**Agenda Item A.1
PUBLIC HEARING
Meeting Date: April 20, 2026**

TO: Goleta Historic Preservation Commission

SUBJECT: Proposed Adaptive Reuse and Renovation to the Fairview Gardens Historic Farmhouse, as part of the Fairview Gardens Conditional Use Permit Project; 598 N. Fairview Avenue; APN 069-090-052; Case Nos. 25-0001-CUP; 25-0003-DRB.

**Farmhouse Existing
Plans**

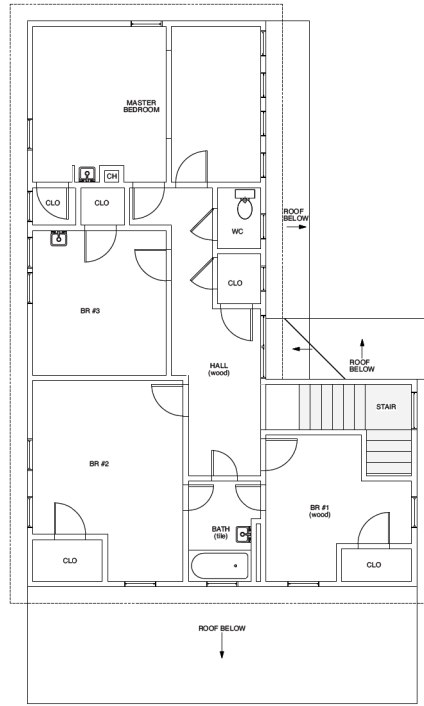
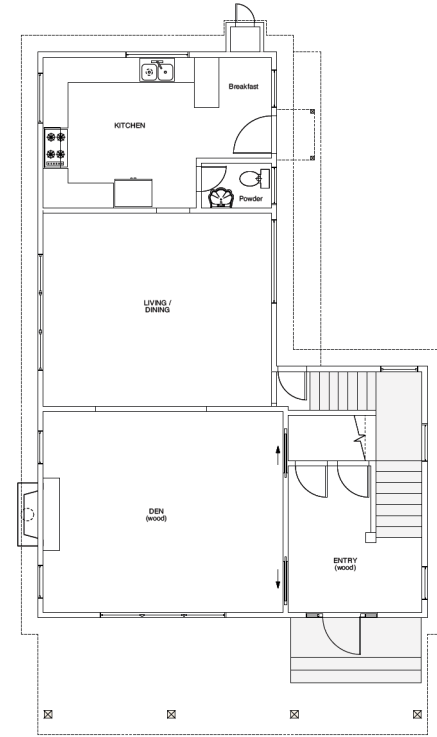
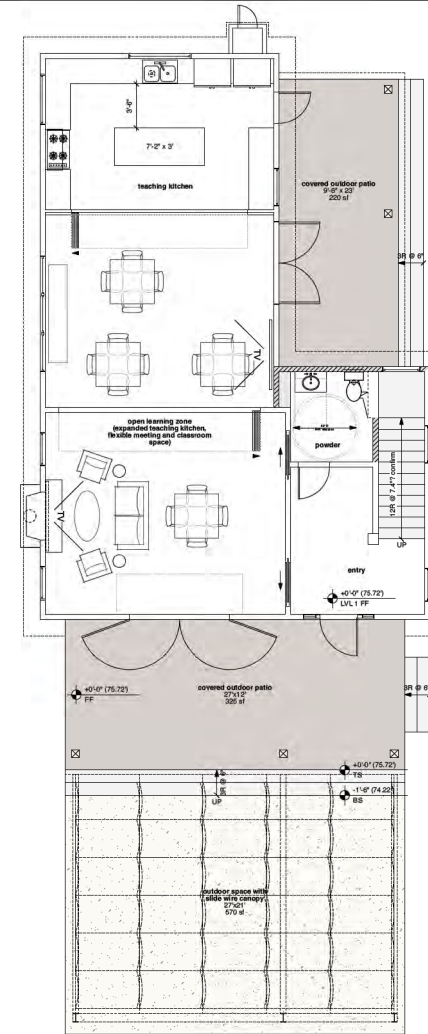
- Install a new foundation. The foundation would be sheathed in wood boards matching the existing skirting in design and materials.
- Repair the farmhouse's exterior walls and roof assembly. Replacement materials including siding, and trim work, will match the originals in material, dimension, profile, and appearance.

- Repair the farmhouse's existing fenestration, including windows that have been covered over. A three-part window on the east elevation's first floor and a double sash window on the south elevation would be replaced with multi-light French doors to improve accessibility.

- Repair the west elevation's brick fireplace. The chimney would be dismantled and rebuilt to meet current code requirements. If feasible the existing bricks would be reused as a veneer.

Proposed Farm House Plan 1
1/4" = 1'-0" 1

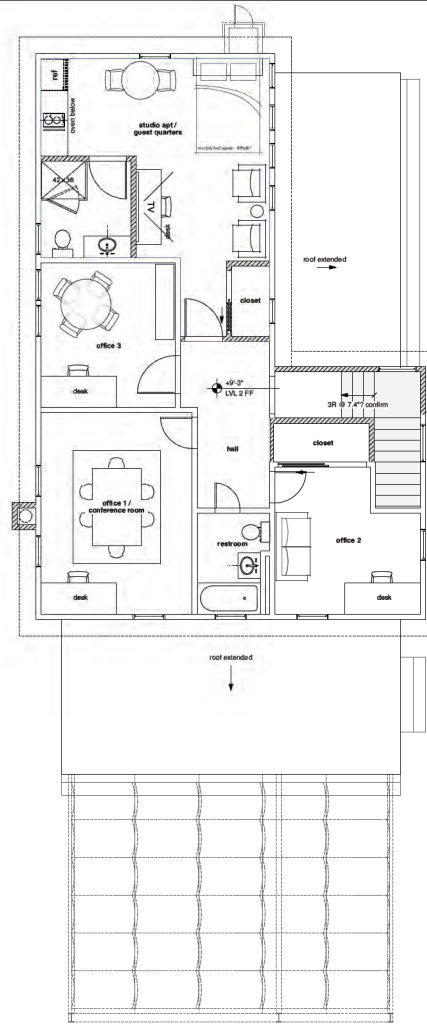
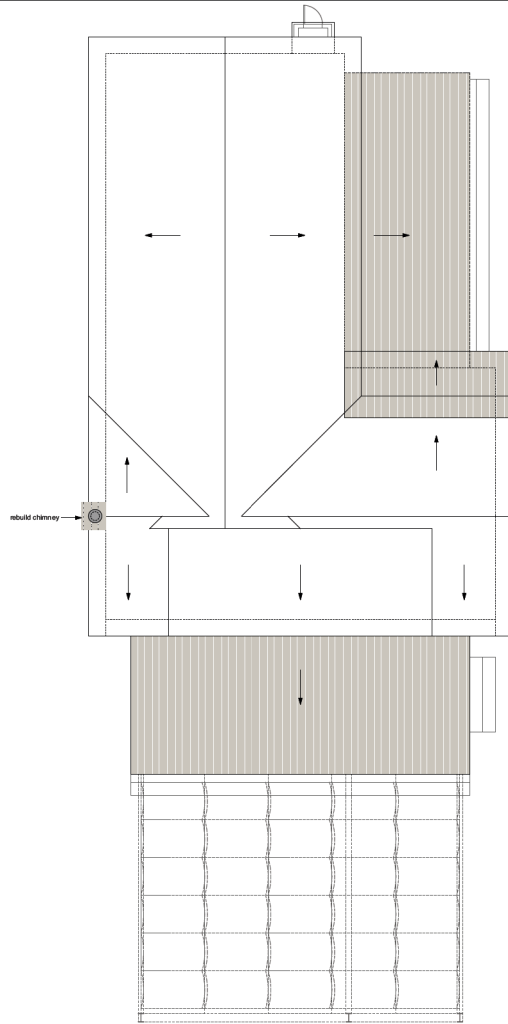
This proposed foundation work would meet Standard 9, provided the visible portion of the new foundation is clad in wood slats to match the existing wood slat cladding of the house's raised foundation.

The remodeled porch on the south elevation would feature a 27-foot by 12-foot raised wood deck, steps, new porch posts, and a new shed roof. The existing porch is likely a replacement based on construction methods used. The original wood porch would likely have been raised with steps leading up to a wood porch deck and the front door. If original materials survive, they are likely limited to the porch's beadboard ceiling. The proposed porch design is appropriate because its materials and detailing emulate the materials and design details of a late nineteenth or early twentieth century porch. This alteration would meet Standard 9, provided the detailing of the porch posts emulates motifs common to late 19th and early 20th-century porch posts, which include moldings at the base and top of the posts.

The replacement of a double sash window on the south elevation with a double French door would remove a window that dates to the period of significance (1874 - c. 1930). The doors are proposed to provide a more accessible entry to the farmhouse while preserving the historic front door and its sidelights. The window proposed for replacement would be stored onsite. The design of the proposed French doors is supportable because they are wood, employ a similar glazing pattern as the house's historic windows with three lights across, do not employ sidelights, and have a paneled element at the bottom of the doors to emulate early 20th century French doors. Therefore, these alterations meet Standard 9.

The existing nine-foot, six-inch by 23-foot non-historic porch at the north end of the east elevation would be rebuilt, capped by a low-pitched shed roof and three wood

posts. The porch shelters a raised deck. The design of the porch and its materials are consistent in scale, design, and materials with the existing farmhouse. An existing triple window located south of the first-floor door would be replaced with double multi-light French doors accessing the interior of the farmhouse. The triple window would be stored onsite. The existing non-historic glazed door at the north end of the east elevation would be replaced. Provided the new door is a paneled wood type, either glazed in its upper register or solid, these alterations meet Standard 9.

The windows proposed for removal are located on the east elevation that has undergone several alterations, including the addition of a porch and the replacement of a door. Removing the triple window, which is not visually prominent because it is located on a side elevation, would not substantially impair the farmhouse's integrity of design, materials, or workmanship because the majority of the building's remaining historic fenestration would be restored. Therefore, these proposed alterations meet Standard 9.
